Contract #: 04-0120F4Cty: SF/ALA Rte: 80 PM: 13.2/13.9File #: 69.25B**QUALITY ASSURANCE -- NON-CONFORMANCE REPORT****Location:** Changxing Island, Shanghai, China**Report No:** NCR-000932**Prime Contractor:** American Bridge/Fluor Enterprises, a JV**Date:** 07-Dec-2010**Submitting Contractor:** Zhenhua Port Machinery Company, Ltd (ZPMC), Changxing Island**NCR #:** ZPMC-0893**Type of problem:****Welding****Concrete****Other****Welding****Curing****Procedural****Bridge No:** 34-0006**Joint fit-up****Coating****Other****Component:** CB19 - Floorbeam diaphragm FB3246**Procedural****Procedural****Description:****Reference Description:** Base Metal Repair without Prior Approval from the Engineer on Crossbeam 19**Description of Non-Conformance:**

Subject: NCR No. ZPMC-0893

Reference Description: Base Metal Repair without Prior Approval from the Engineer on Crossbeam 19

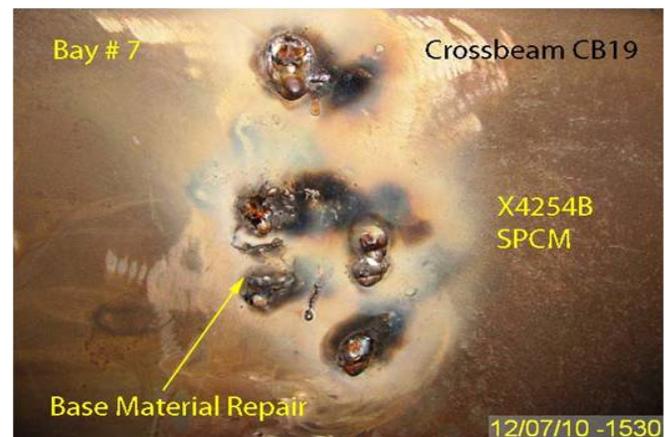
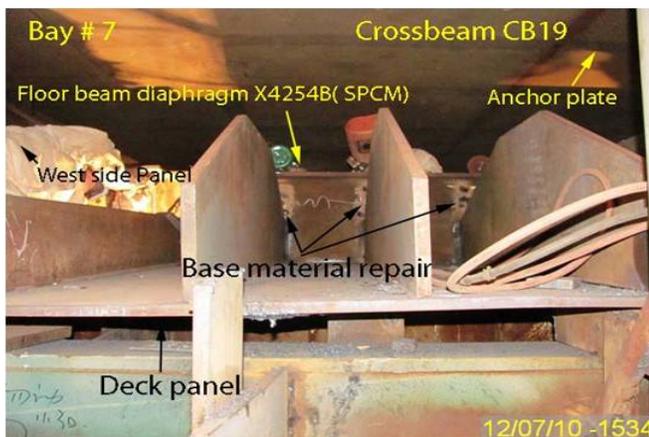
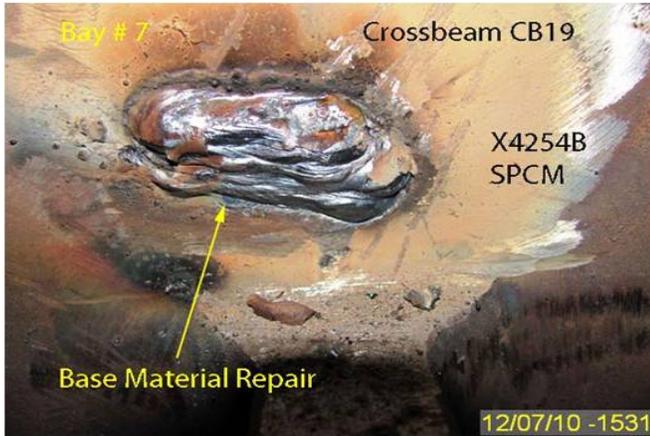
During the Quality Assurance (QA) random in-process visual inspection of Orthotropic Box Girder (OBG) Crossbeam CB19, this QA inspector discovered the following issue:

- Base metal repairs being performed without prior approval of the Engineer.
- Repairs were being performed in runoff tab removal areas on the Floor beam diaphragm web plate.
- Floor beam diaphragm is identified as FB3246
- Web plate is identified as X4254B (SPCM)
- The material is A709 Grade 345 Seismic Performance Critical Member (SPCM).
- OBG Cross beam CB19 is located in the Bay 7.

For further information, please see the attached pictures.

Caltrans Special Provision Section 8-3.01: "The Engineer shall be notified immediately in writing when welding problems, deficiencies, base metal repairs, or any other type of repairs not submitted in the WQCP are discovered and also of the proposed repair procedures to correct them. For requests to perform repairs, The contractor shall include an engineering evaluation of the proposed repair."

ZPMC Welding Quality Control Plan, Section 9.2.1.2: "Prior approval of the Engineer shall be obtained for repairs to base metal other than what was identified in Section 9.2.1.1 of this manual and the repair of all other cracks."

AWS D1.5/2002, Section 3.7.4: "Prior approval of the Engineer shall be obtained for repairs to base metal."

Contractor will repair the defective area, and provide the NDT report to prove the repairs are completed satisfactorily. ZPMC will issue an internal NCR to the QC personnel and will discuss with shop floor CWI regarding the requirement of seeking Engineer's approval prior to any base metal repair.

Contractor repaired the defects. NDT reports provided subsequently show the repairs are acceptable. Contractor also reinforced to the shop floor CWI's that the Engineer needs to be notified prior to base metal repair.

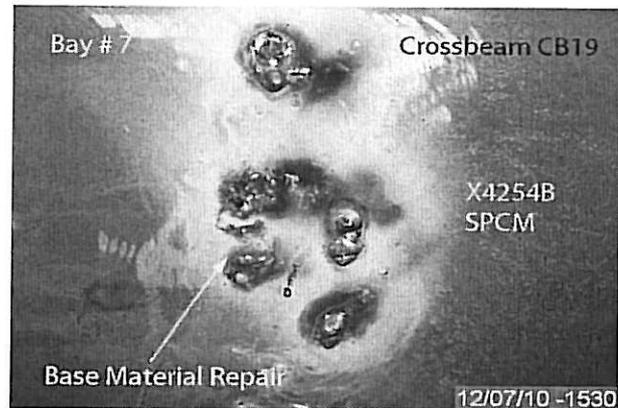
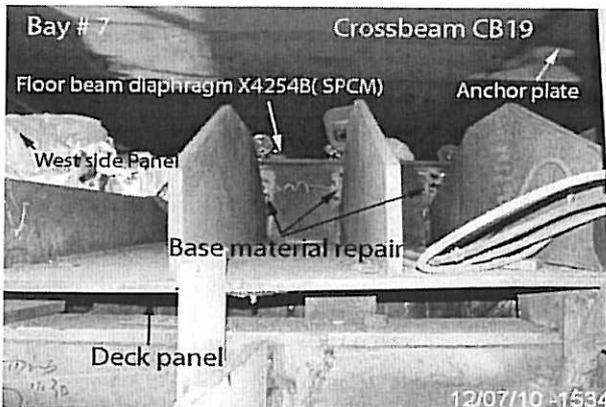
During the Quality Assurance (QA) random in-process visual inspection of Orthotropic Box Girder (OBG) Crossbeam CB19, this QA inspector discovered the following issue:

- Base metal repairs being performed without prior approval of the Engineer.
- Repairs were being performed in runoff tab removal areas on the Floor beam diaphragm web plate.
- Floor beam diaphragm is identified as FB3246
- Web plate is identified as X4254B (SPCM)
- The material is A709 Grade 345 Seismic Performance Critical Member (SPCM).
- OBG Cross beam CB19 is located in the Bay 7.

For further information, please see the attached pictures.

Caltrans Special Provision Section 8-3.01: "The Engineer shall be notified immediately in writing when welding problems, deficiencies, base metal repairs, or any other type of repairs not submitted in the WQCP are discovered and also of the proposed repair procedures to correct them. For requests to perform repairs, The contractor shall include an engineering evaluation of the proposed repair."

ZPMC Welding Quality Control Plan, Section 9.2.1.2: "Prior approval of the Engineer shall be obtained for repairs to base metal other than what was identified in Section 9.2.1.1 of this manual and the repair of all other cracks."

AWS D1.5/2002, Section 3.7.4: "Prior approval of the Engineer shall be obtained for repairs to base metal."
